KENWOOD

SB-930

SERVICE BULLETIN AMATEUR RADIO

SUBJE	ECT		DATE	
	TM-721A	MICROCOMPUTOR LOCK-UP	4/11/88	3

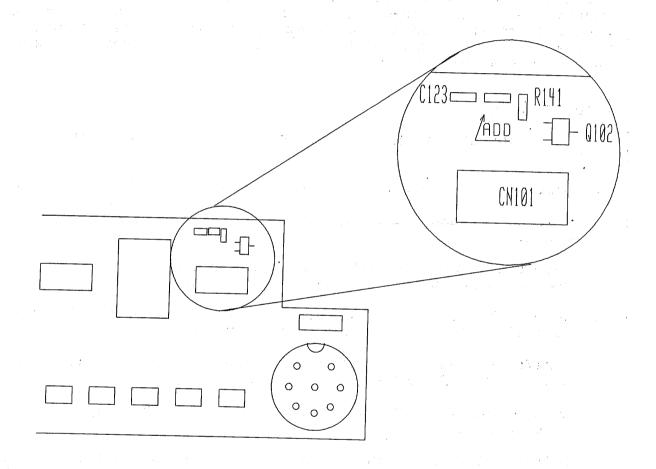
Some early model TM-721A transceivers may malfunction when nearby transmissions (such as operating a handheld too close to the unit) enter the microprocessor reset circuit. As the RF energy enters the circuit, the microprocessor ceases to function which results in shutting off the sub-display, receiver, and transmitter. Adding a capacitor to the base of the reset switching transistor on the control unit will correct this condition. The following procedure will detail how to access the transistor.

- 8. Straighten the display unit mounting clips and pull the display unit from the control board (do not disconnect the cable).
- 9. Locate Q102 on the top right hand side of the control board (next to the volume control).
- 10. Add a 1000pF chip capacitor between the base of Q102 and ground (the capacitor will physically be mounted between C123 and R141).
- 11. Assemble the transceiver by reversing the steps above.
